# UNITED STATES PATENT AND TRADEMARK OFFICE

APPLICATION NO.	FILING DATE	FIRST NAMED INVENTOR	ATTORNEY DOCKET NO.	CONFIRMATION NO.
10/057,535	01/24/2002	Curtis White	BSC-159C1	3017

# Office Action Summary

FIG. 5F

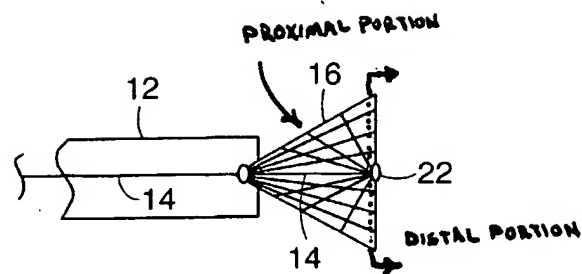
Claims 18, 23, 28, 30 and 33 are rejected under 35 U.S.C. 102(e) as being anticipated by Bates (U.S. 6,096,053). Bates teaches a medical retrieval device (Figs. 2 and 5F; See marked-up copy of Fig. 5F attached to this Office Action) comprising: a proximal handle 18; a sheath 12 extending from the handle 18 and including a lumen, the sheath 12 including a distal end away from the handle 18; a retrieval assembly 16 that is moveable relative to the sheath 12 to achieve a collapsed position of the retrieval assembly 16 within the lumen, the retrieval assembly 16 comprising: a proximal portion comprising a distal end and a three-dimensional shape when at least a portion of the retrieval assembly 16 extends out of the lumen from the distal end of the sheath 12; and a distal portion positioned at the distal end of the proximal portion, the distal portion comprising a flat shape perpendicular to a long axis of the device when the proximal portion extends from the distal end of the sheath 12; further comprising a guidewire 14 joined to a central portion 22 of the distal portion of the retrieval assembly; wherein axial movement of the guidewire 14 in a proximal direction collapses the distal portion of the retrieval assembly 16; wherein moving the sheath 12 in a distal direction causes the retrieval assembly 16 to collapse when it enters the lumen. Concerning the language of claim 23 requiring the distal portion of the retrieval assembly comprise a plurality of wires, one should note lines 23-39 of column 3 where Bates describes the construction of mesh portion 16 being of woven fibers or metal wires. Bates describes a method for
